**RELEASE FOR
CONSTRUCTION
AS NOTED ON PLANS REVIEW
DEVELOPMENT SERVICES
LEE'S SUMMIT, MISSOURI**

SHOP DRAWINGS/SUBMITTAL REVIEW

ROOF TRUSS LAYOUT	
PAGE	
<i>1 of 1</i>	
JOB No.	2809580
DESCRIPTION	Summit Homes - 102 Hawthorne Ridge
JOB ADDRESS	3105 SW Arbor Tree Dr.
CITY	Lee's Summit, MO
DESIGNER	Scott Clevenger
DATE	5/26/2021

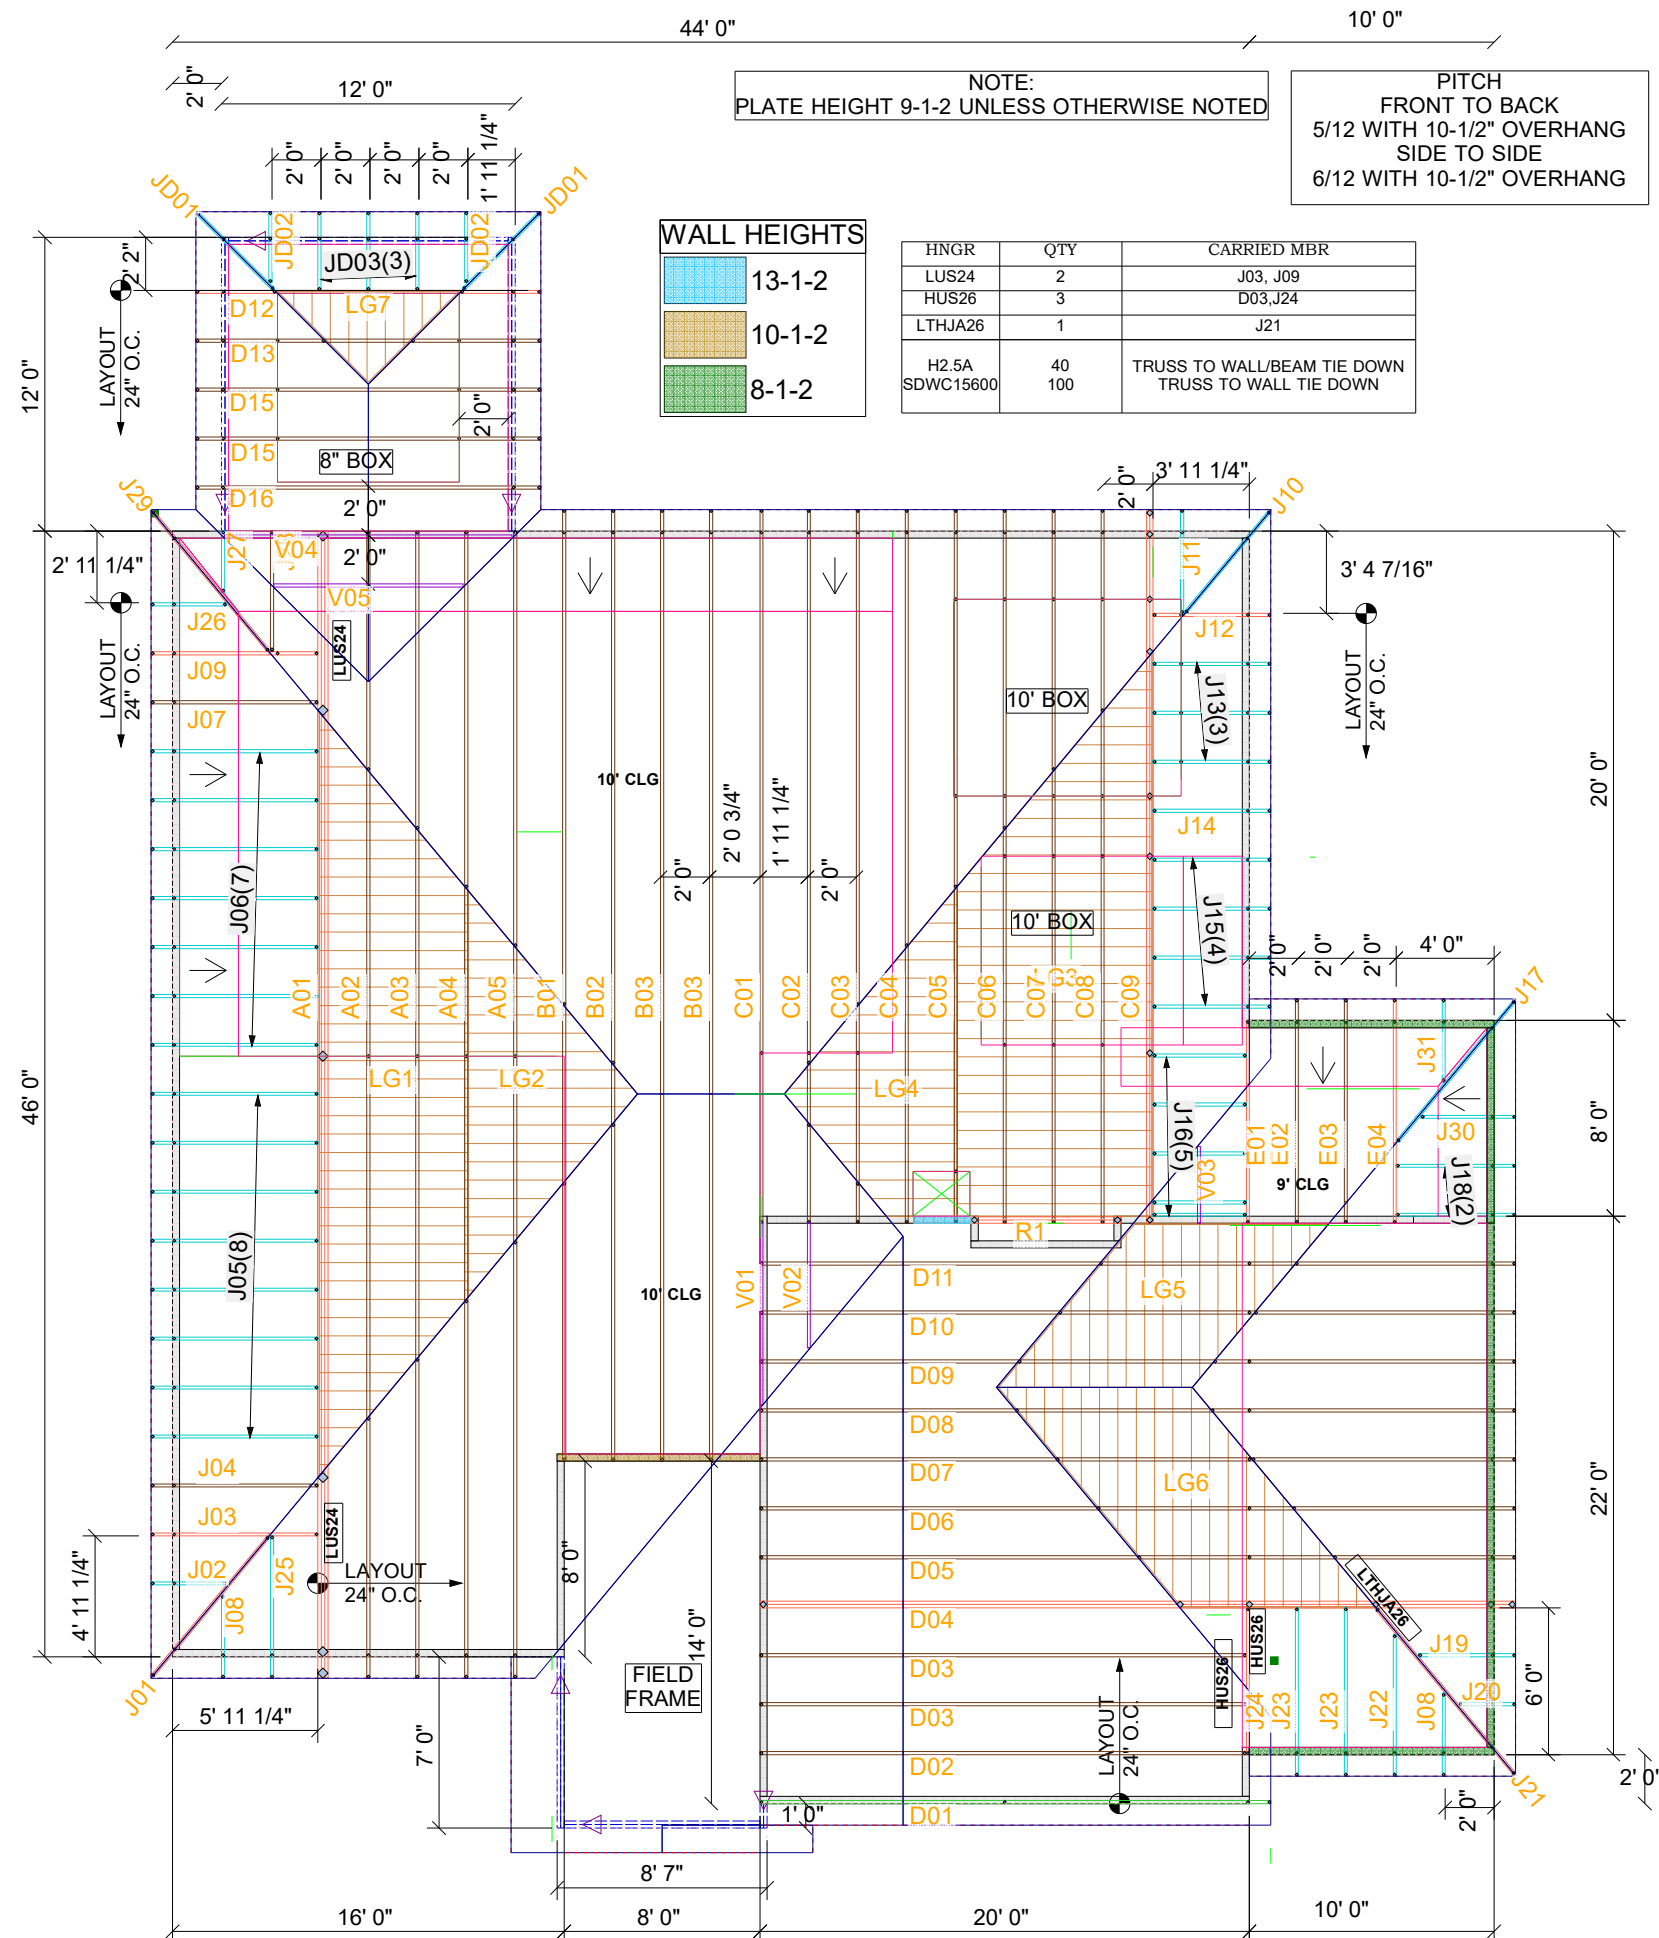
APPROVED
